Subject: Eaton FR Transmission

Models Affected: Specific Freightliner Cascadia, Business Class M2, 108SD, and 114SD vehicles and Western Star 4700 vehicles manufactured January 4, 2015, through April 24, 2015, with certain Eaton FR 10-speed manual transmissions.

Recall Campaign

November 2015
FL693A
NHTSA #15V-617

Fig. 1, Spacer Identification

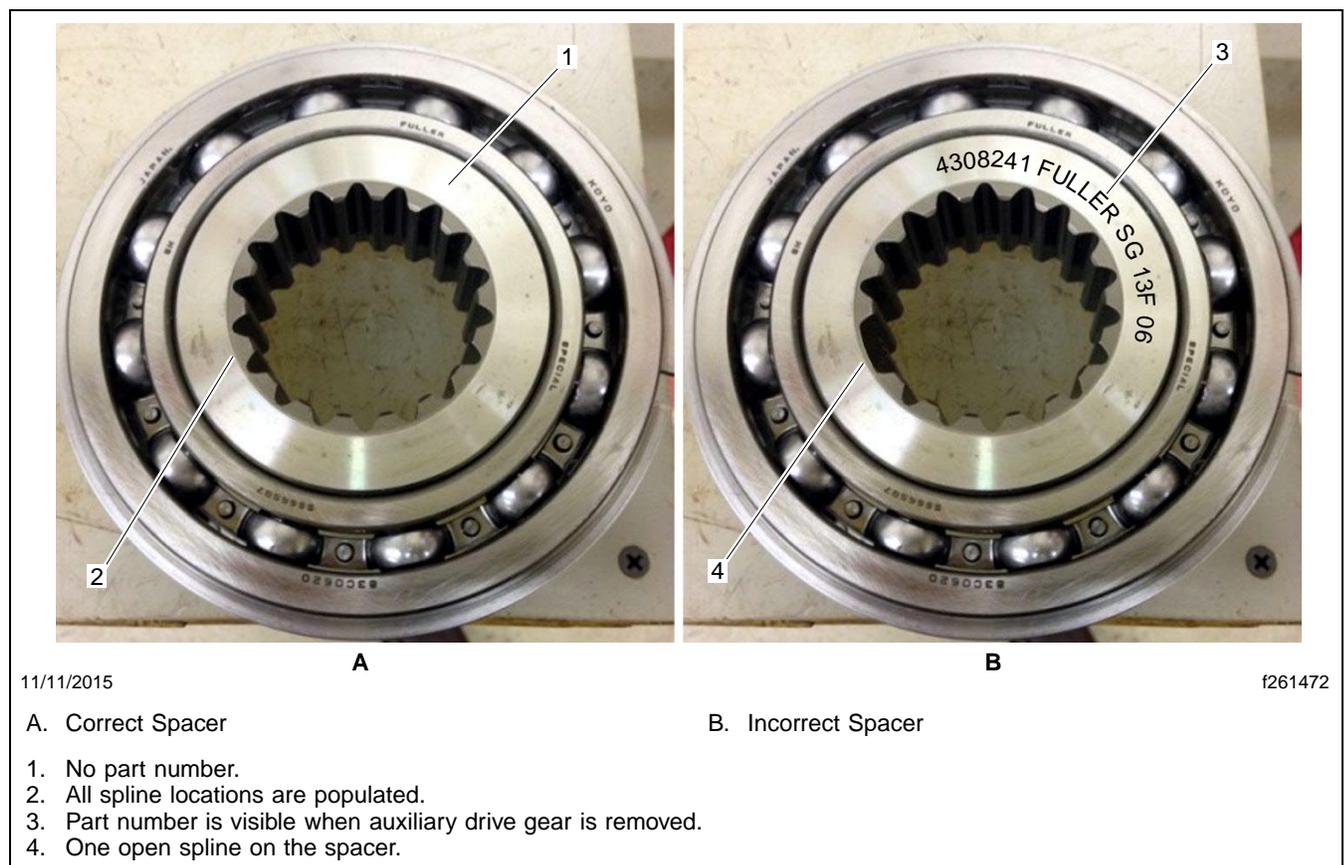
The correct spacer does not have an open spline or a visible part number printed on it. **Fig. 1**, Ref A shows the correct spacer, and Ref B shows the incorrect spacer. Submit photographs to RTW for verification regardless of the spacer installed.

If the spacer has an open spline and the part number 4308241 is visible, go to step 19.

If the spacer has all the possible splines engaged with the mainshaft and no visible part number, go to step 20.

19. Work with RTW to perform a detailed inspection of the main transmission components for damage. If damage is found, remove the transmission; see "Transmission Removal and Installation" in these work instructions.
20. Move the shift bar housing from the top of the transmission.
21. Install the auxiliary drive gear and snap ring.
22. Clean the sealing surfaces of the main case, shift bar housing, auxiliary section, and shift tower.
23. Set a new shift bar housing gasket in place.
24. Position the shift bar housing, using a spacer block to allow the auxiliary section to be installed.
25. Install the auxiliary section. Tighten the capscrews 40 to 45 lbf-ft (54 to 61 N·m).
